Technical Note: Failure to provide Safe and Suitable Access to SA29

Mid-Sussex District Council: Sites Allocation Draft Development Planning Document

Proposed Allocation of SA29 Land South of St Stephen's Church, Hamsland, Horsted Keynes

Extract from Highway Code: Rule 243

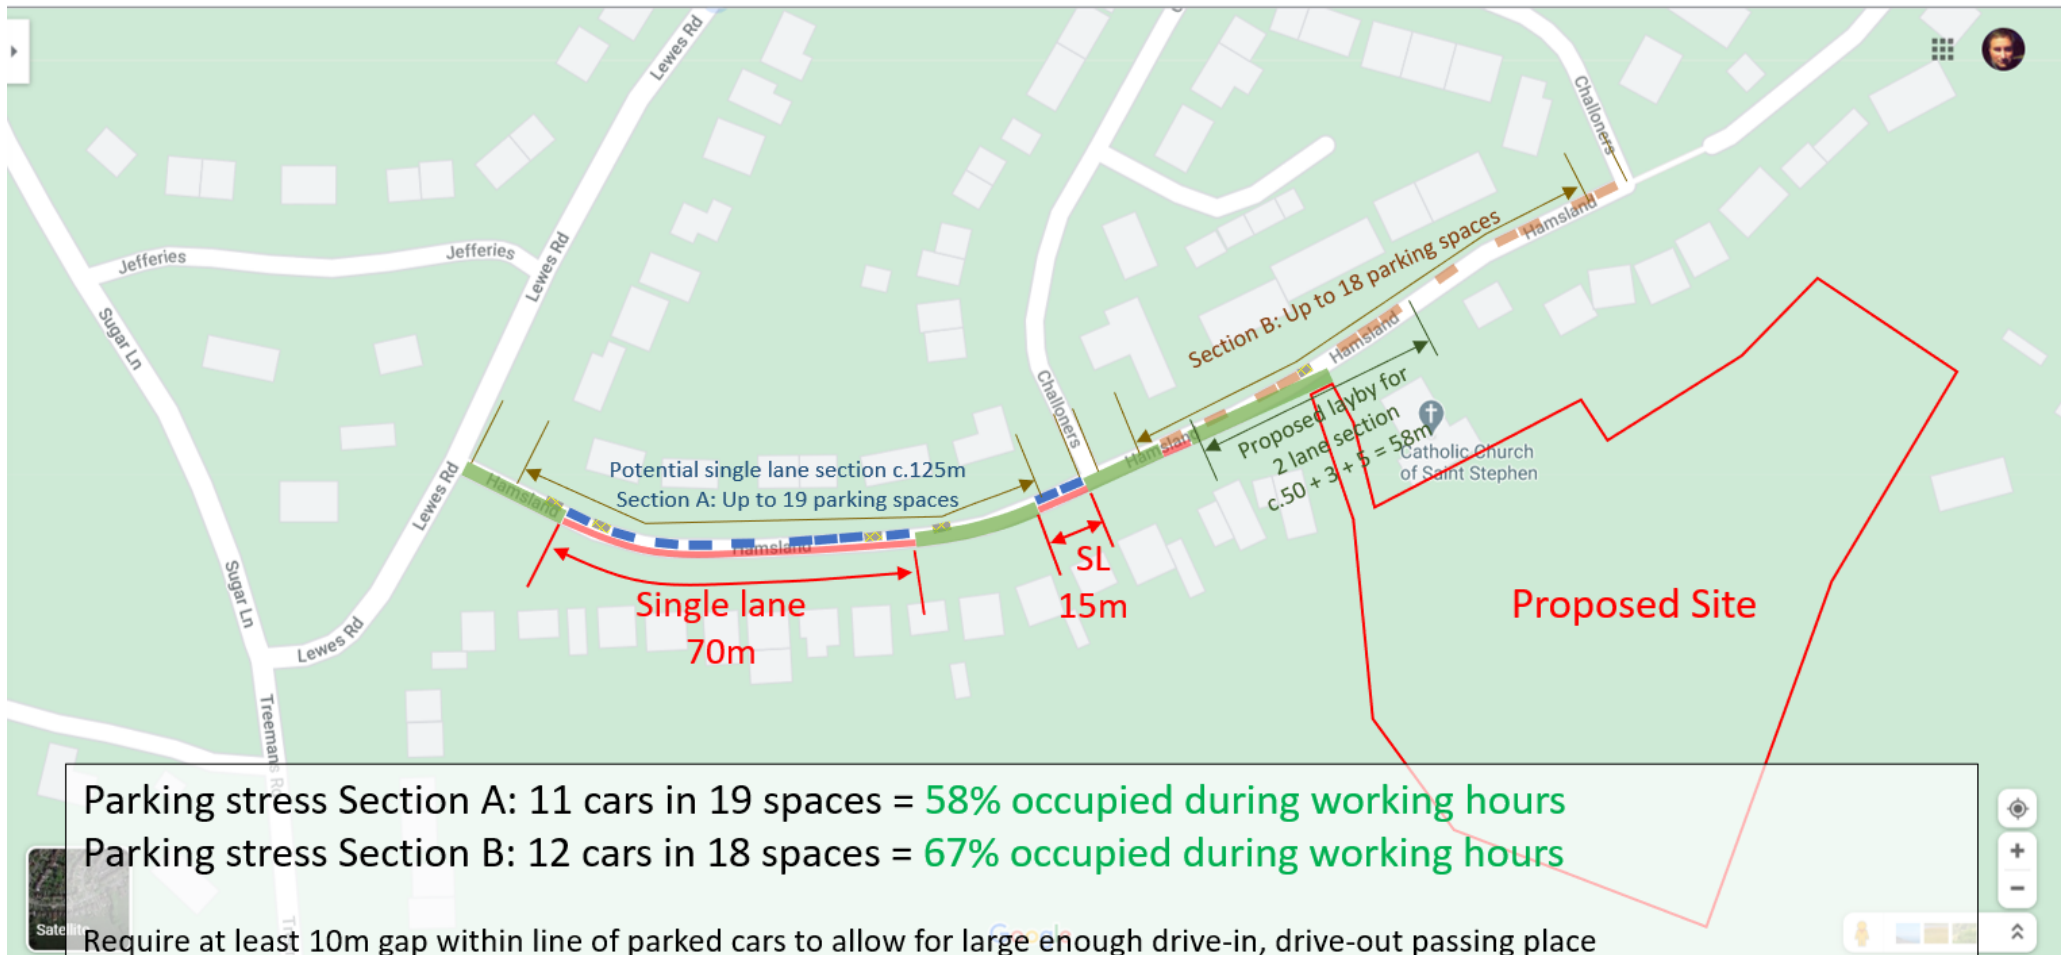
Parallel parking: widespread guidance is to allow 6 linear metres length per space for reverse in, drive out parking
Permits up to **37 parking spaces** complying with Highway Code, **not the 42 parking spaces used in the parking stress survey**

Passing places in single lane sections: Look for at least 10 linear metres to permit drive in, drive out passing manoeuvre

Parking survey: 09:15-09:30 Friday 5th February

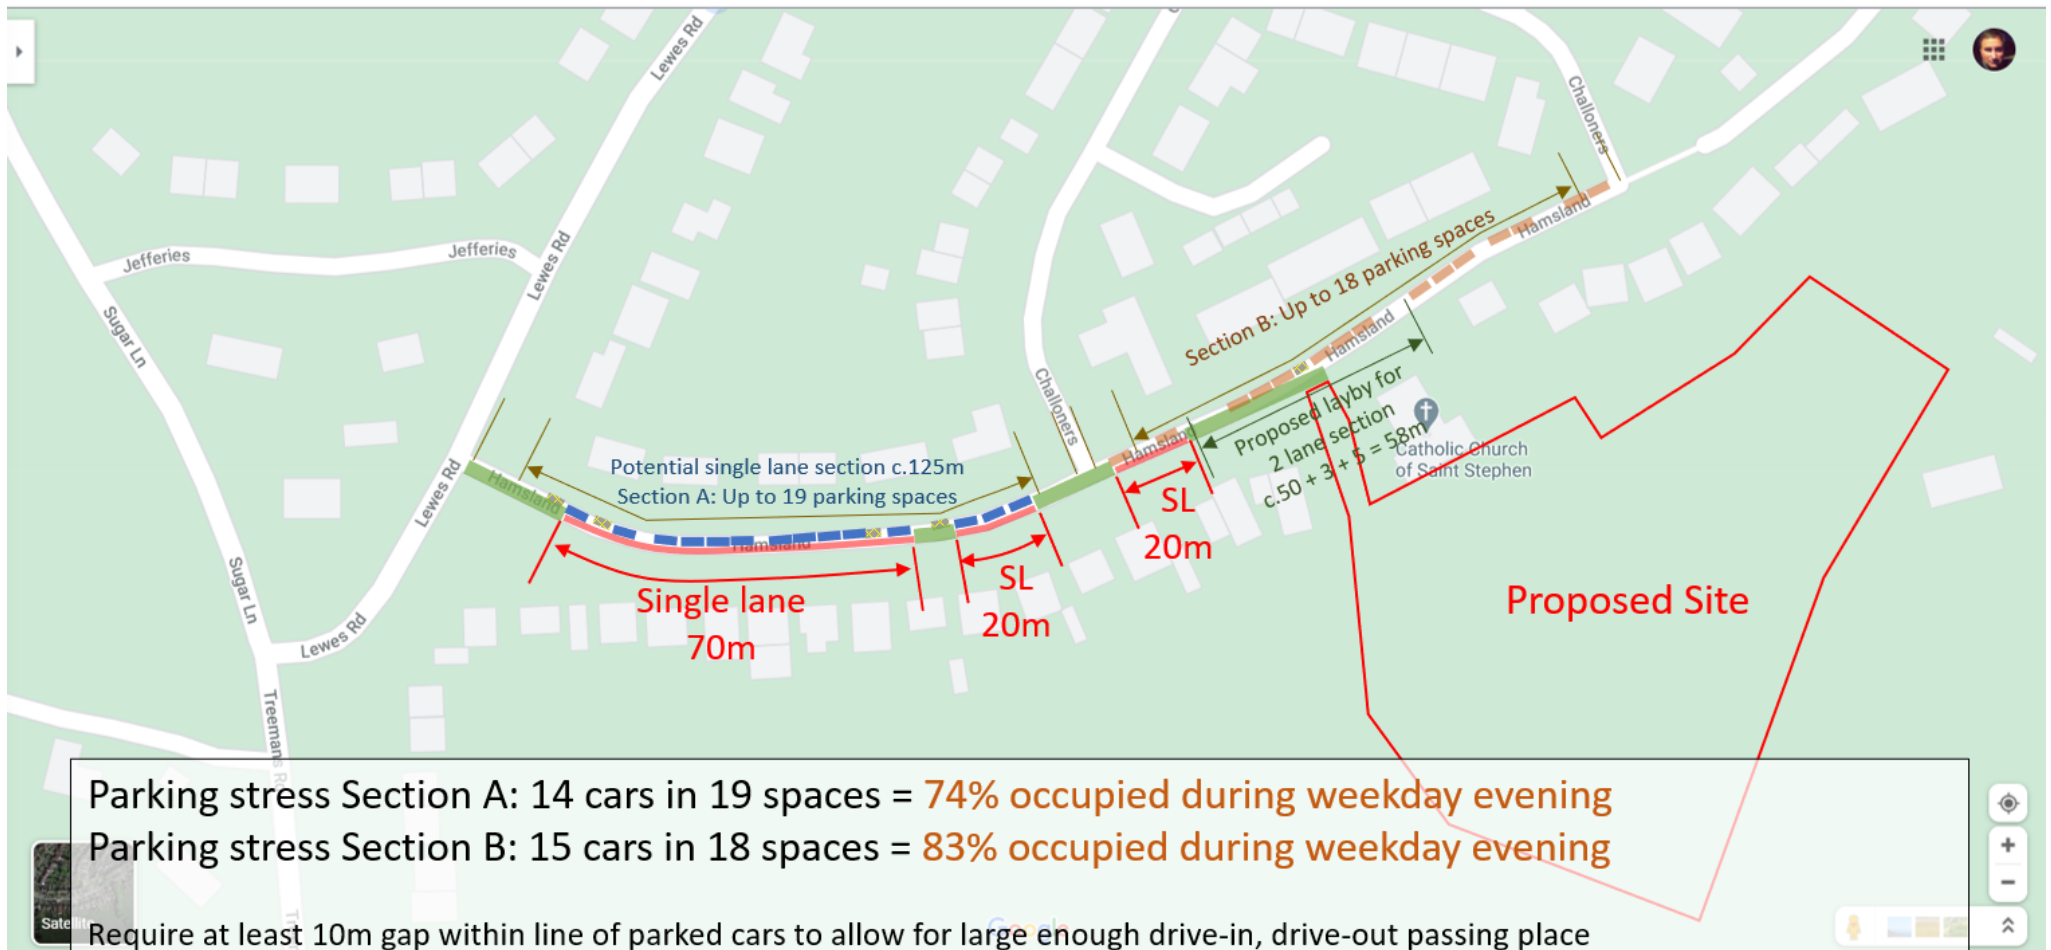
Parking stress Section A: 11 cars in 19 spaces = 58% occupied during working hours

Parking stress Section B: 12 cars in 18 spaces = 67% occupied during working hours

Significant single lane lengths: c.70m single lane length with blind bend

c.15m single lane length straight

Parking survey: 18:15-18:30 Friday 5th February

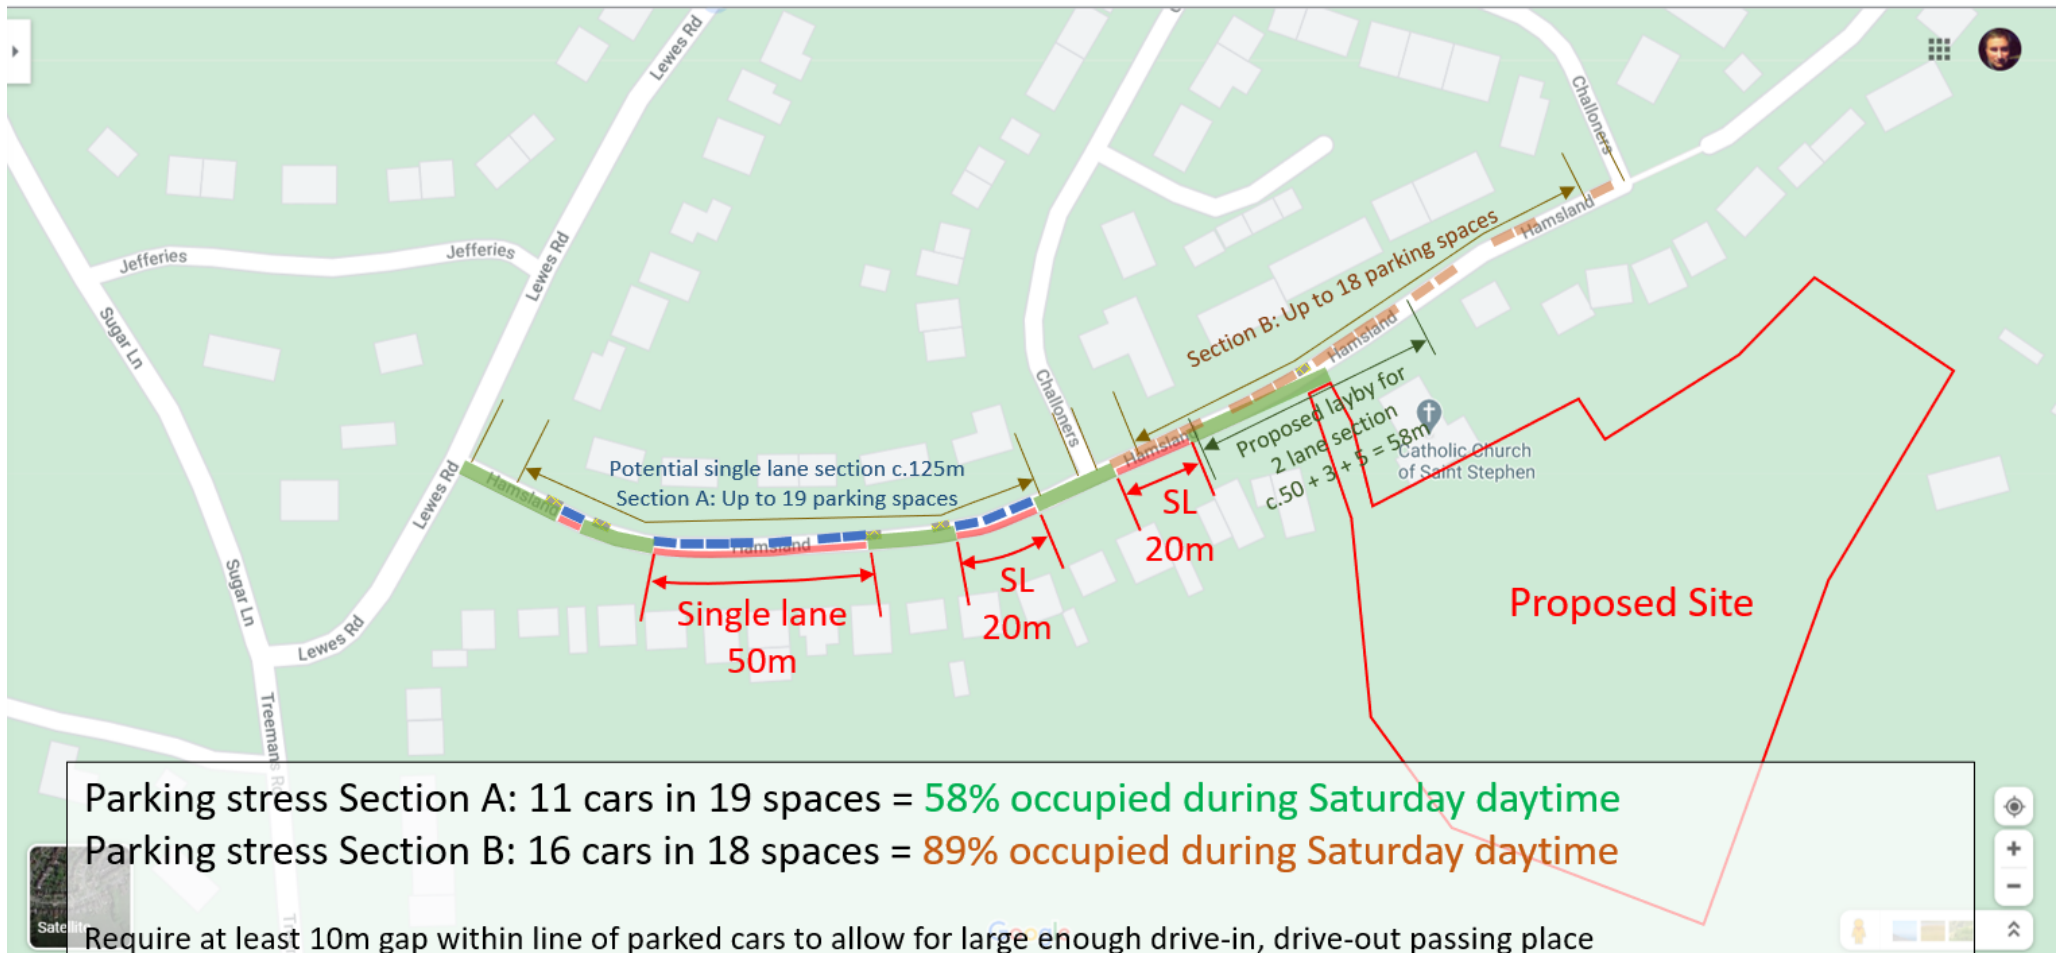
Parking stress Section A: 14 cars in 19 spaces = 74% occupied during weekday evening

Parking stress Section B: 15 cars in 18 spaces = 83% occupied during weekday evening

Significant single lane lengths:

- c.70m single lane length with blind bend
- c.20m single lane length with bend
- c.20m single lane length straight

Parking survey: 09:30-09:45 Saturday 6th February

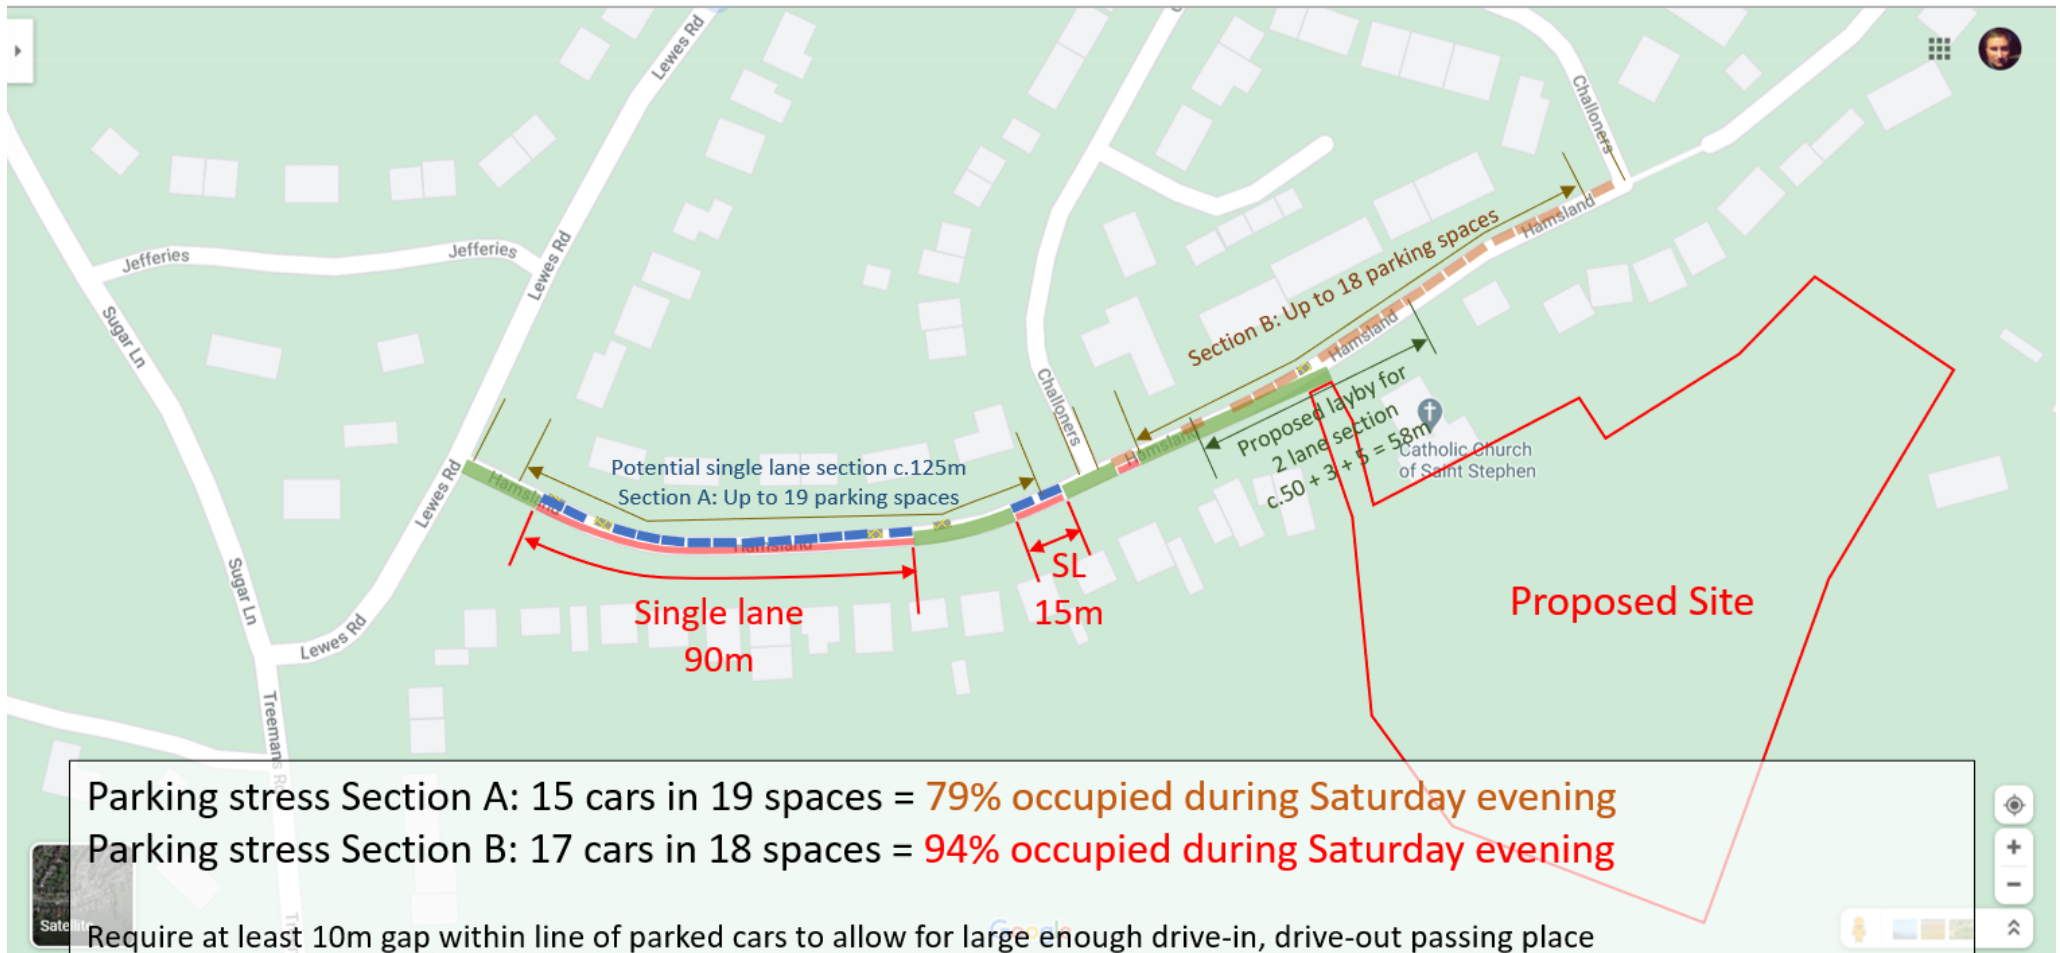
Parking stress Section A: 11 cars in 19 spaces = 58% occupied during Saturday daytime

Parking stress Section B: 16 cars in 18 spaces = 89% occupied during Saturday daytime

Significant single lane lengths:

- c.50m single lane length with bend
- c.20m single lane length with bend
- c.20m single lane length straight

Parking survey: 20:30-20:45 Saturday 6th February

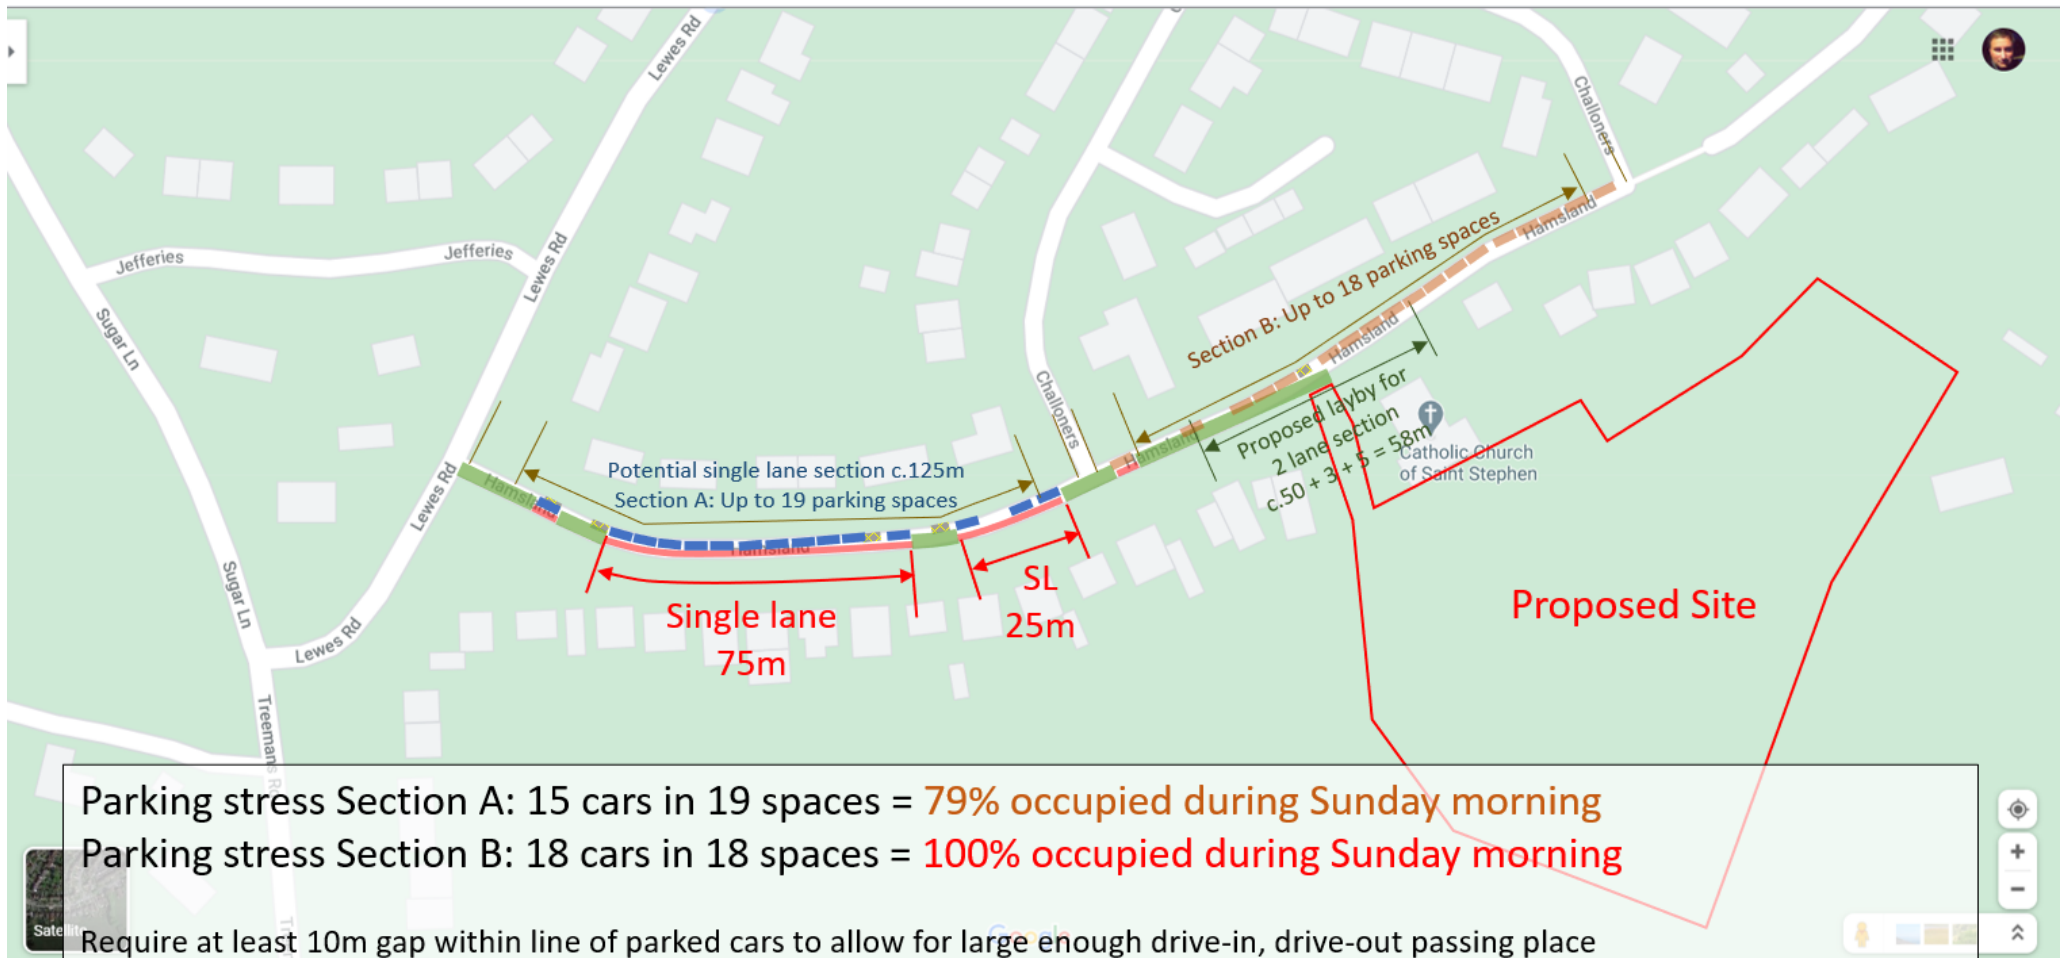
Significant single lane lengths: **c.90m single lane length with blind bend**
c.15m single lane length straight
